2001 - 2003 Corvette: Service Manual Update: Revised Wheel Drive Shaft Outer Joint and Seal Replacement and Wheel Drive Shaft Inner Joint and Seal Replacement Procedures

Number: 03-04-95-001 - (01/09/2003)

Models: 2001-2003 Chevrolet Corvette

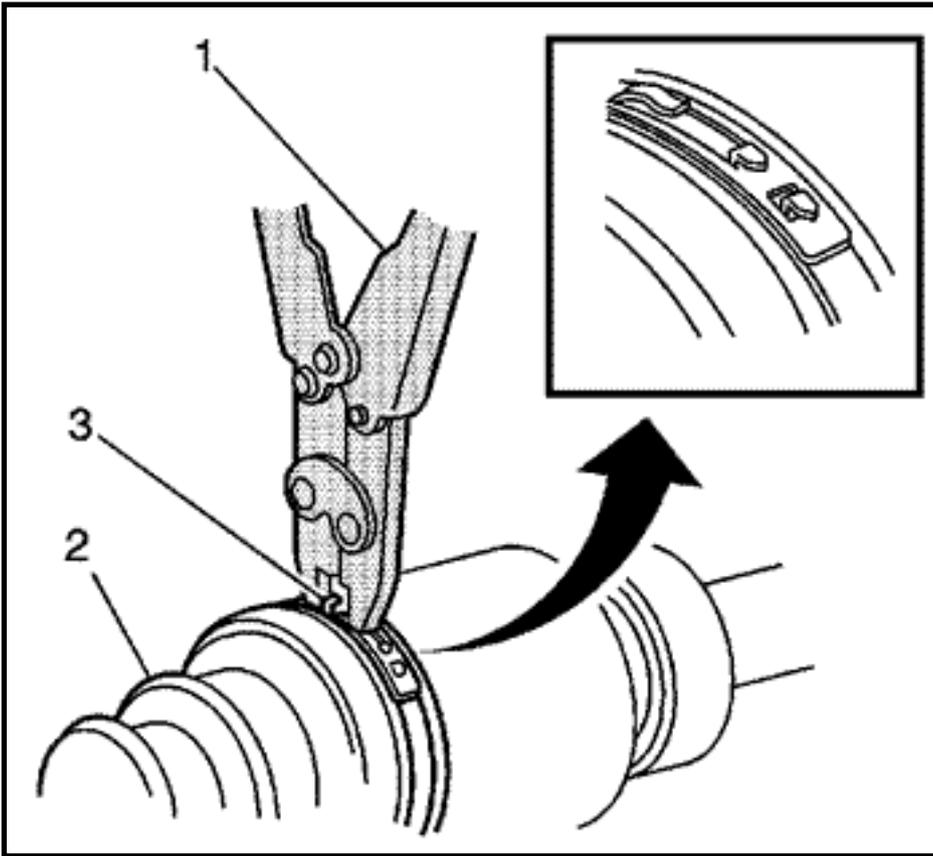
Because of a mid-year change in 2001, the large diameter clamp is now a low profile design, instead of the Omega clamp design. The new design clamp requires the use of Special Tool J 46588 to install. The following steps effect 2001 model year vehicles with the second design clamp and all 2002 and future model year vehicles.

Align the following items while latching:

- The wheel drive shaft inboard seal (2)
- The tripot housing
- The large seal retaining clamp (3)

Using the J 46588 (1), latch the large seal retaining clamp. Ensure that the latching tangs are fully engaged in the large seal clamp band.
